Report to Development Permit Panel

File: DP 17-782793

Re: **Application by Christopher Bozyk Architects Ltd. for a Development Permit at 4331 and 4431 Vanguard Road**

1. **DP 17-782793 - 8,576 SQ.M. THREE-STOREY INDUSTRIAL BUILDING
VEHICLE STORAGE AND REPAIR**

4431 & 4331 VANGUARD RD
PROPOSED VEHICLE STORAGE FACILITY
 DEV. PERMIT APPLICATION #DP-17-782793
ELEVATIONS

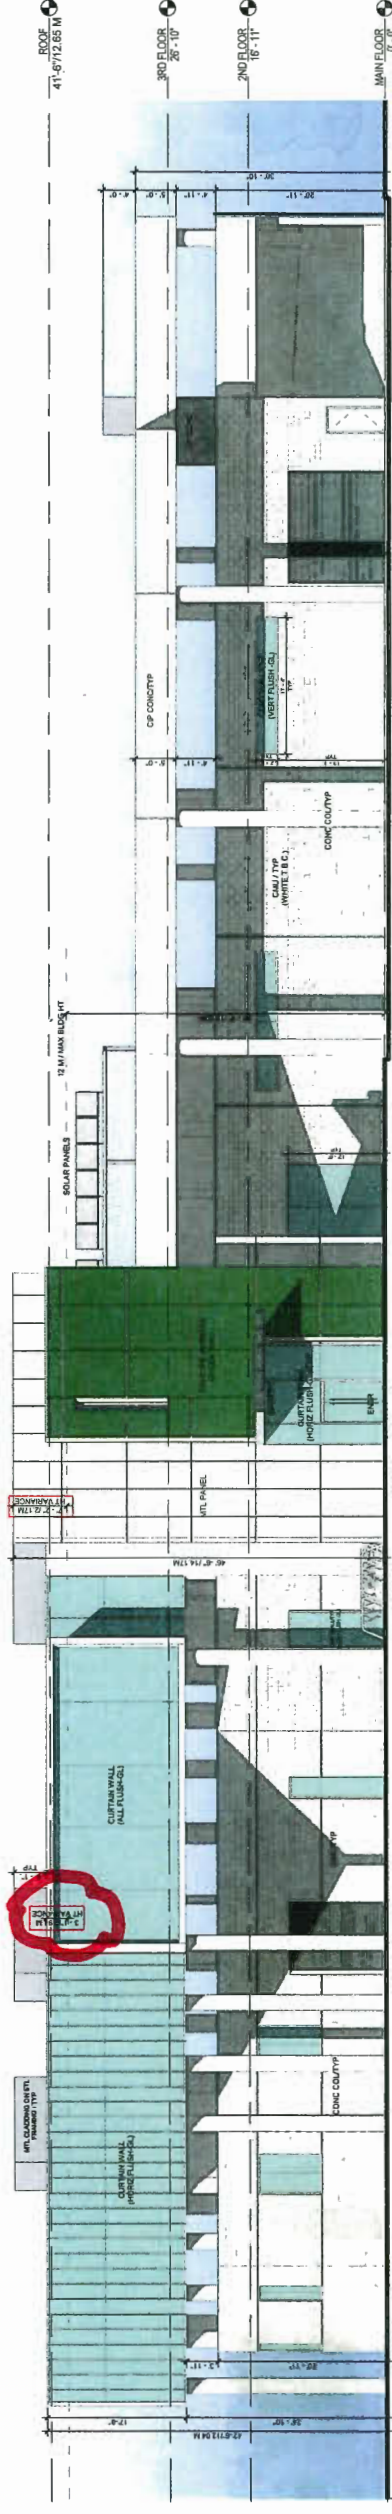
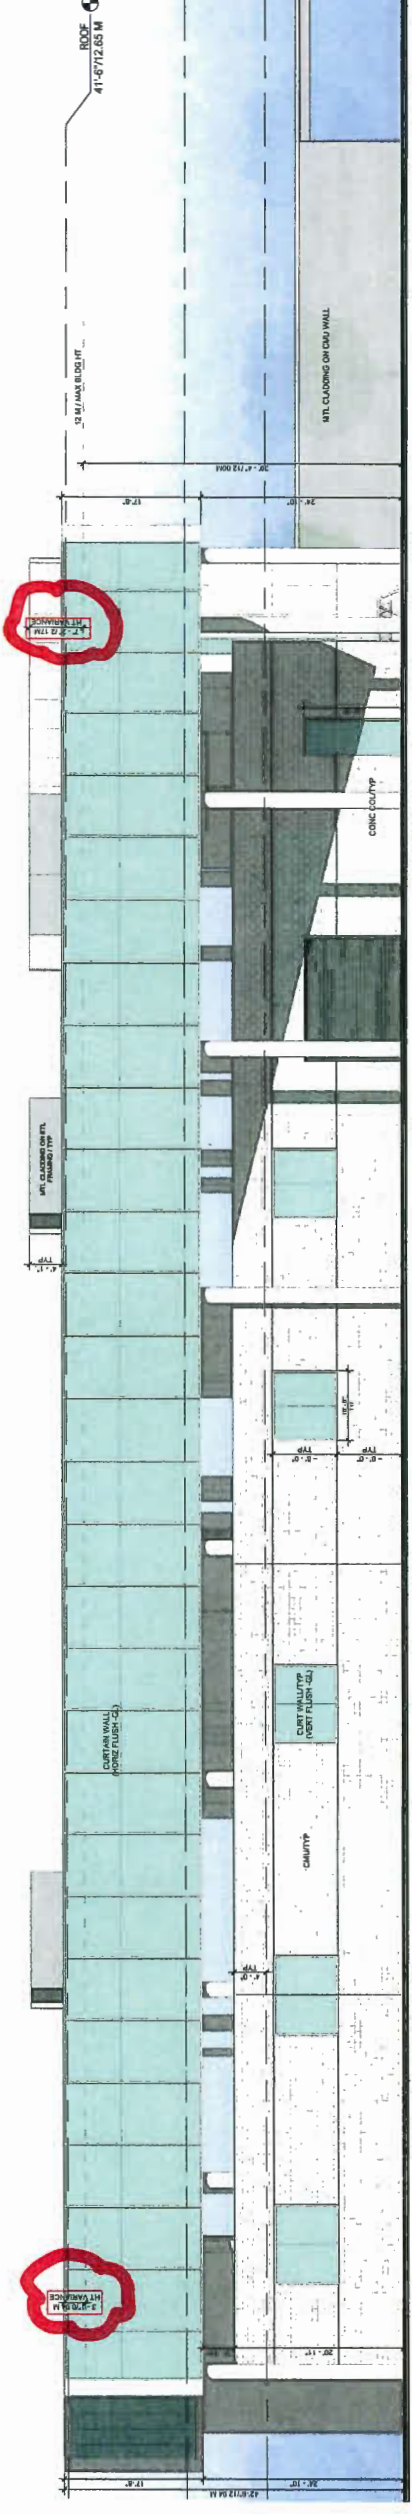
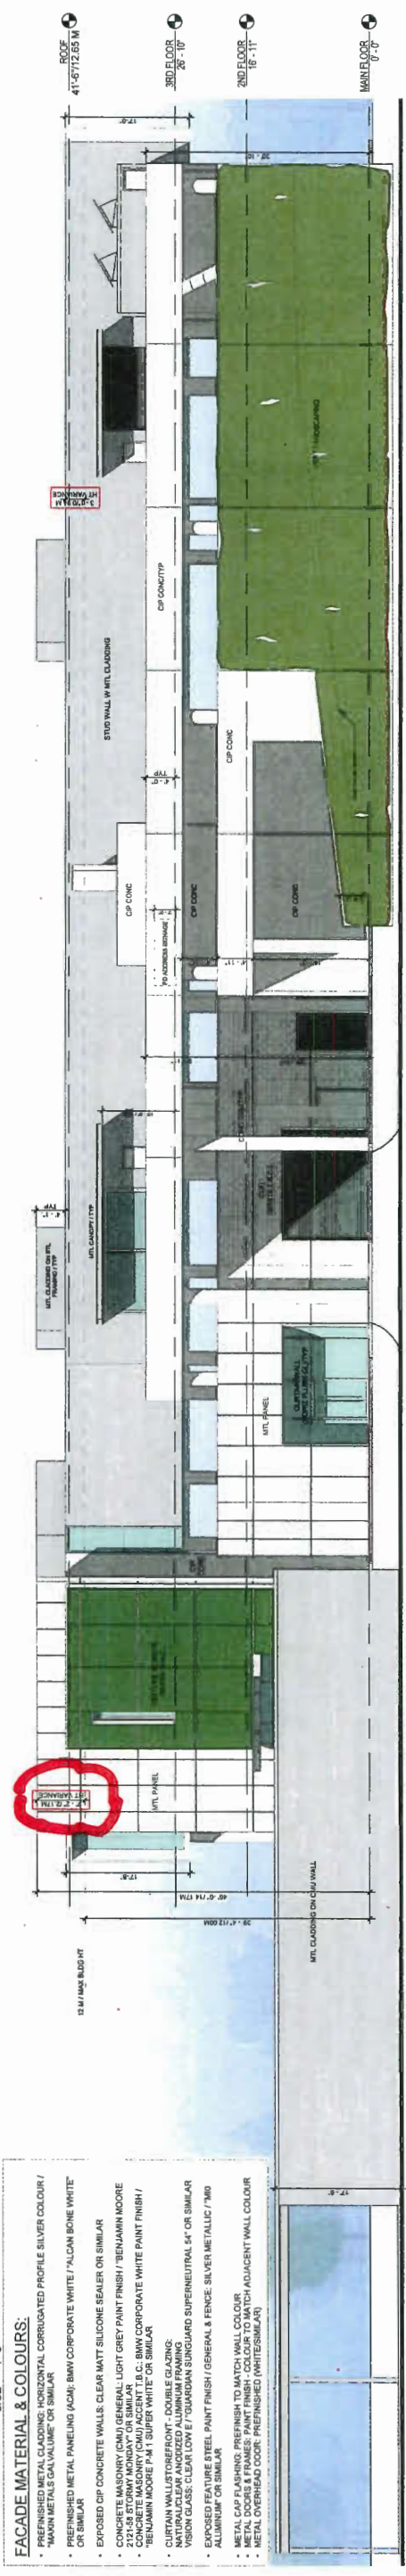
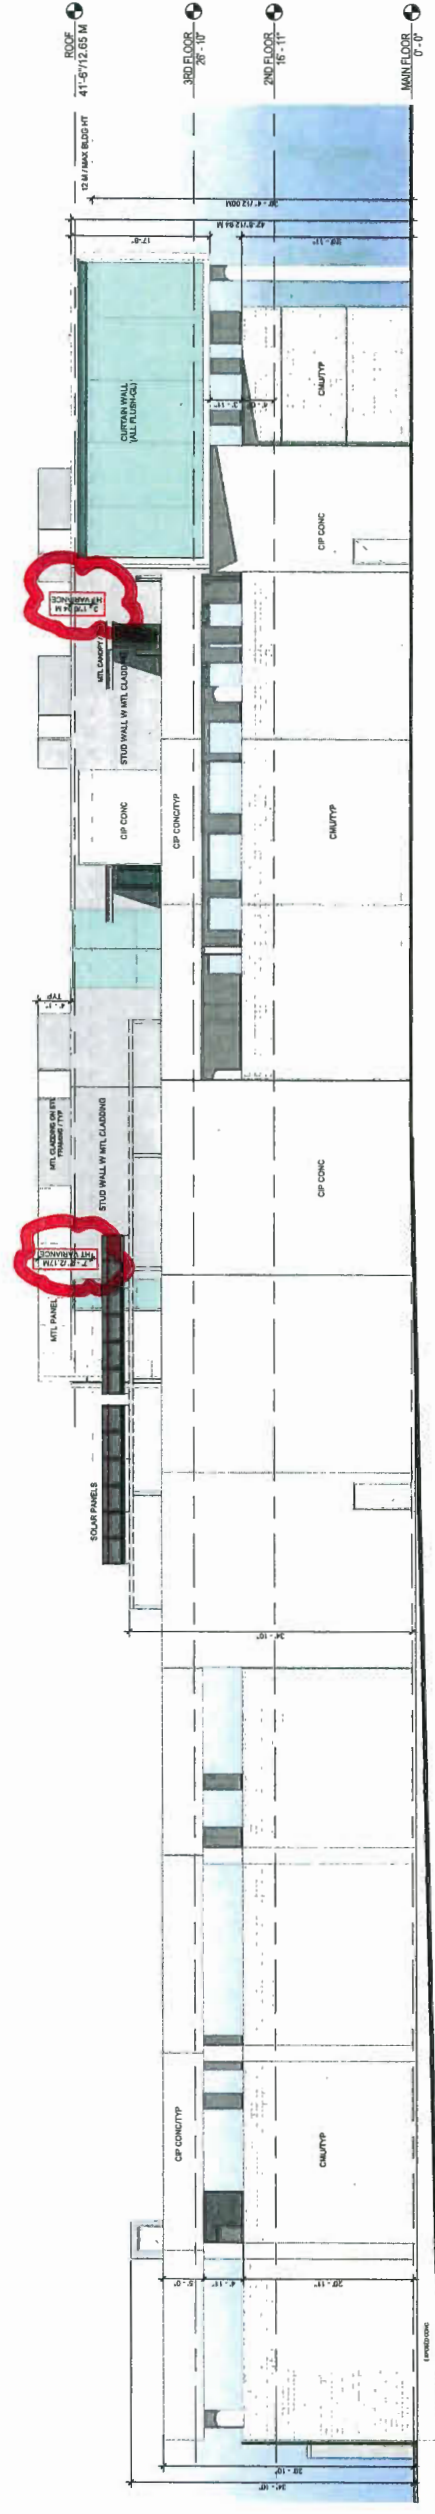
2. consider articulating the blank wall of the car wash building along Vanguard Road to provide visual interest and a better public interface considering its proximity to the site entry;

14. consider introducing screening or diffusion to the Vanguard Road elevation of the car wash building to soften up the elevation’s barren appearance; could add texturing to the east façade of the car wash building to mitigate its blank wall appearance considering its proximity to the site entry;

Compared to the formal complexity of the main building, and due to the high functionality of the car wash layout, it is felt that the current simplicity of the east façade is the appropriate expression and that visual interest and articulation should rather be achieved indirectly by means of landscaping in front of the façade. See submitted revised landscape drawings, showing the introduction of new planting to address this matter.

See comments under 2 above.

With regard to “texturing”, note that the corrugation of the proposed metal cladding is a texture

DRAWING TITLE: LANDSCAPE PLAN

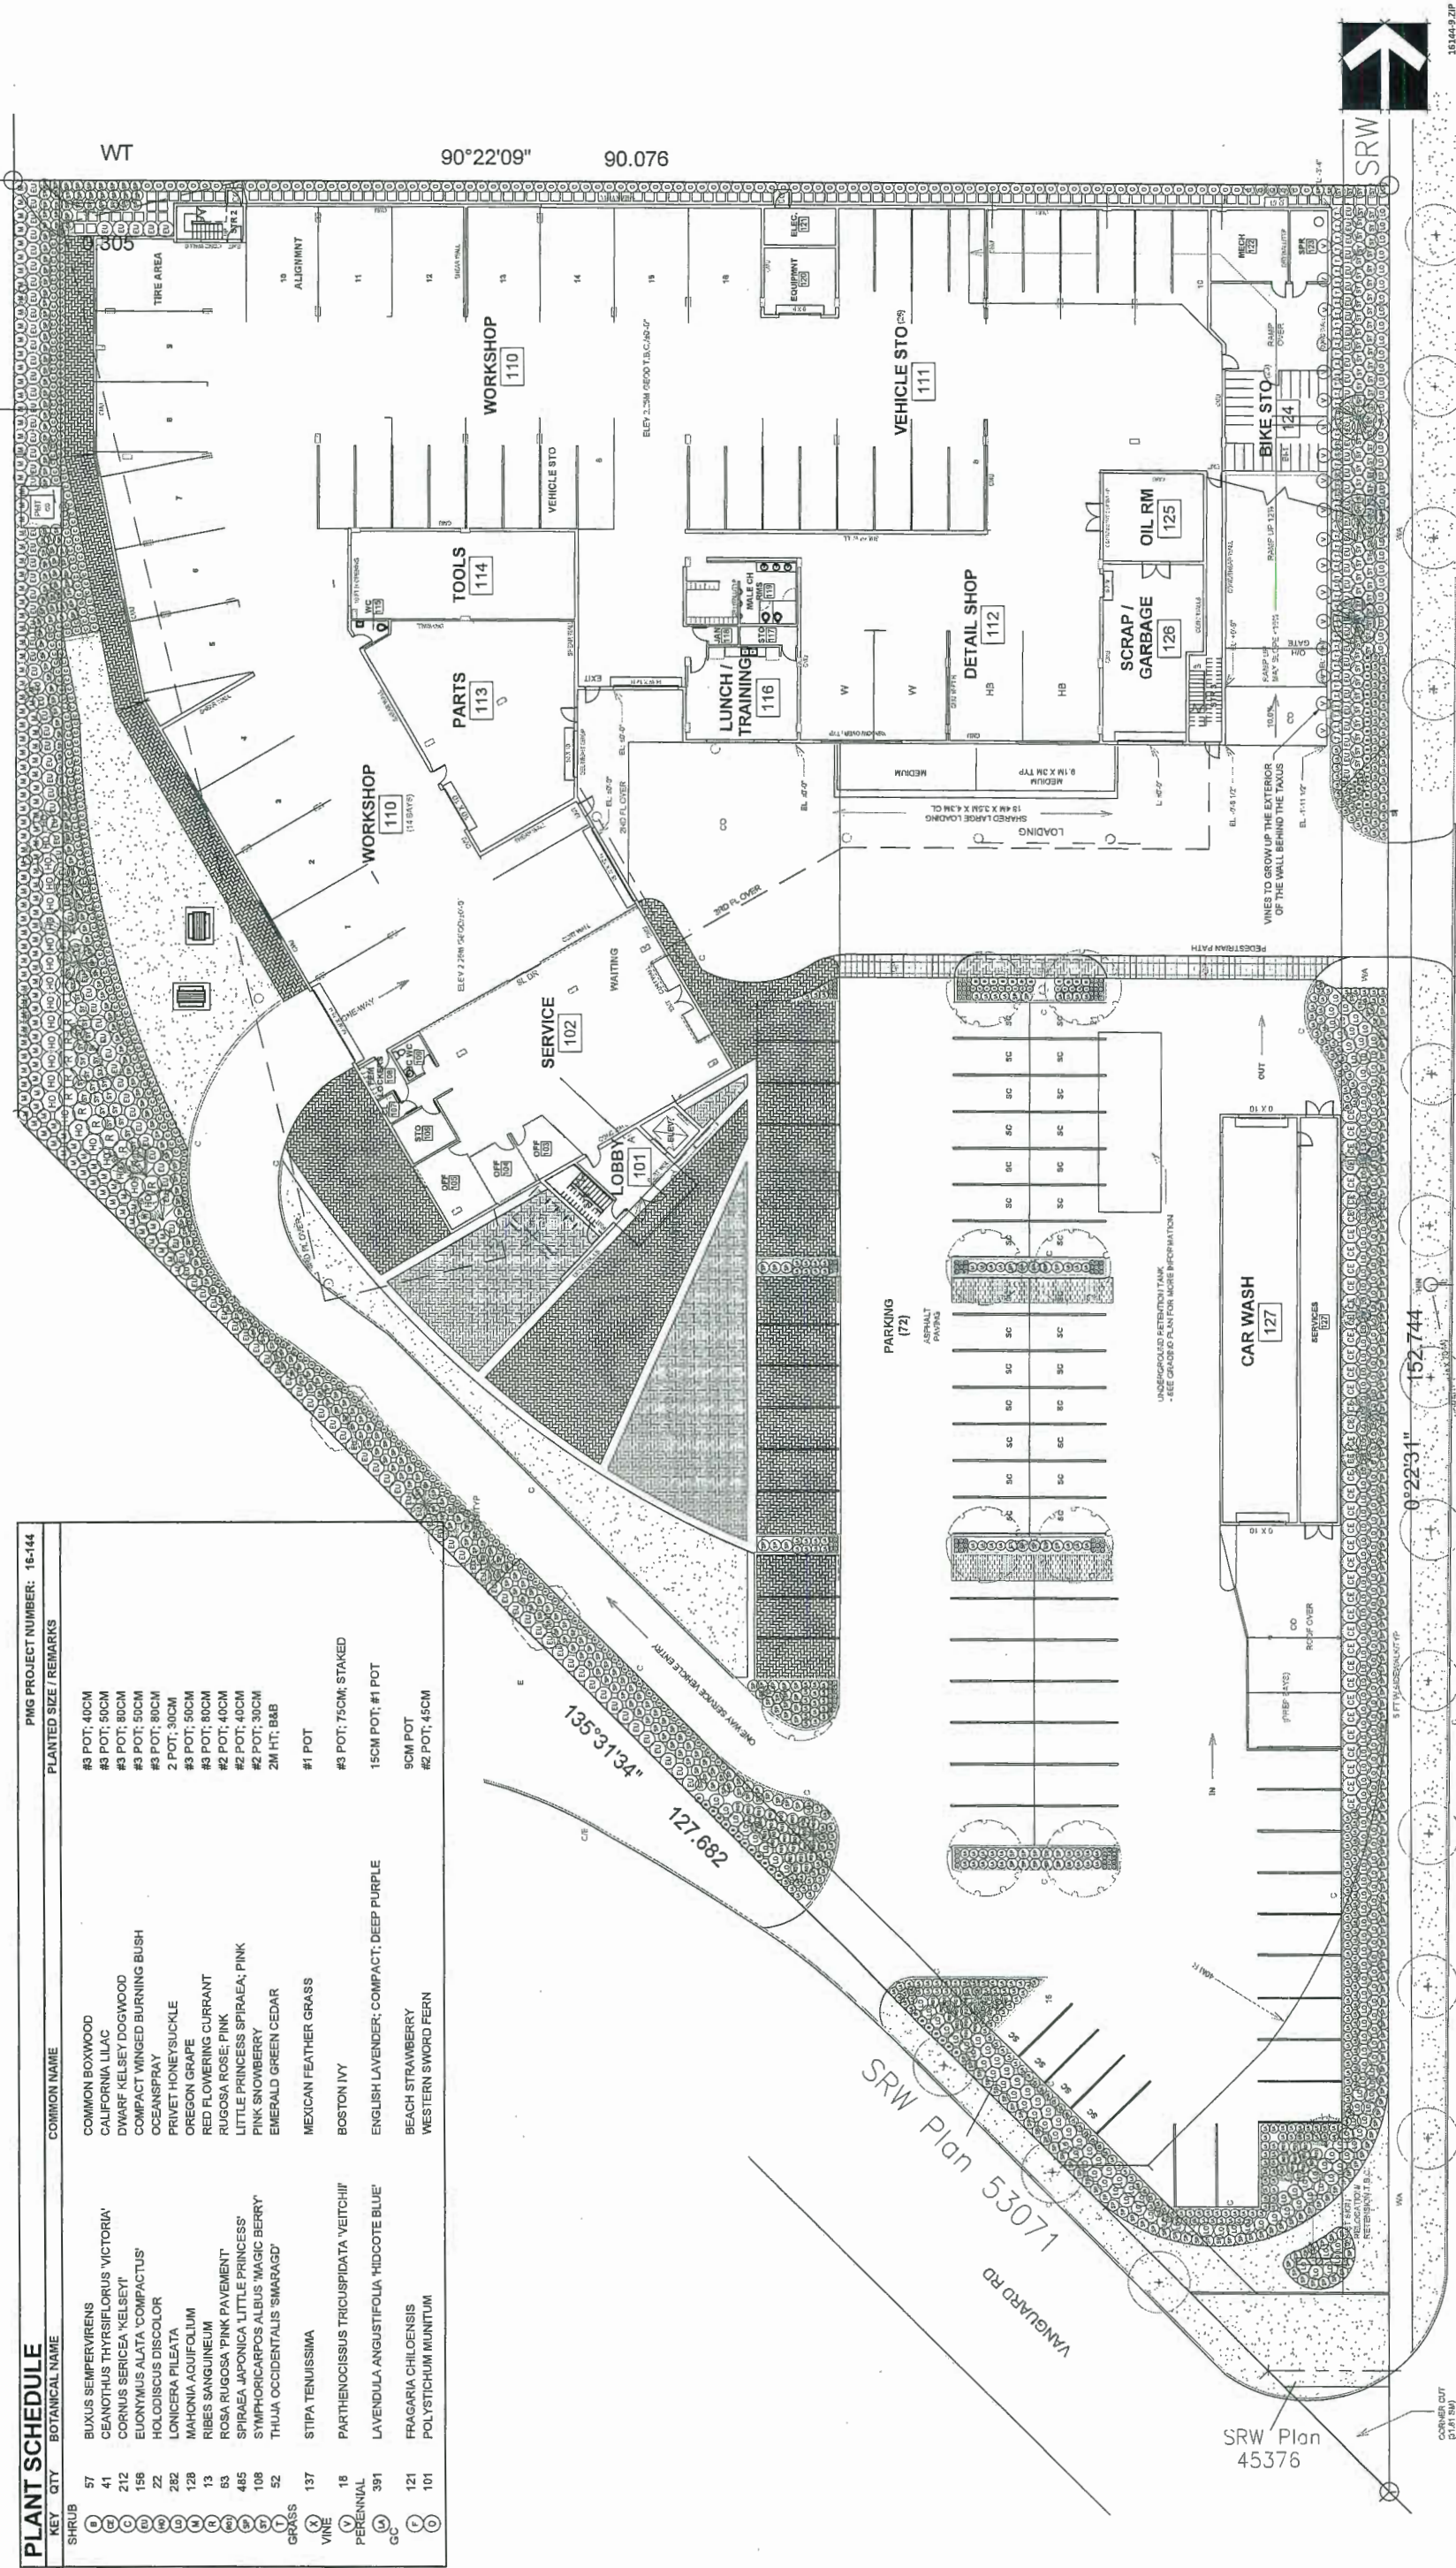
3. consider differentiating the landscaping at the corner of the site entry adjacent to the carwash building, e.g. through varying the height and species of planting at the corner, to emphasize the entry to the site and the pedestrian path to the main building and improve its public interface;

37. survivability of planting along the pathway on the north side of the main building is not certain; consider installing permeable pavers on the pathway in lieu of planting;

43. note that the elevation of the car wash building is higher than the adjacent sidewalk along Vanguard Road; consider installing big, bold, long and linear form of planting along the entire east edge of the site in keeping with the proposed long and linear building form; would create a bigger impact along the Vanguard Road elevation than the proposed green wall;

See submitted revised landscape drawings, showing planting reconfiguration to address this matter.

Planting has been replaced with pavers. See submitted revised landscape drawings.

Planting has been adjusted along Vanguard Road to improve the appearance. See submitted revised landscape drawings.
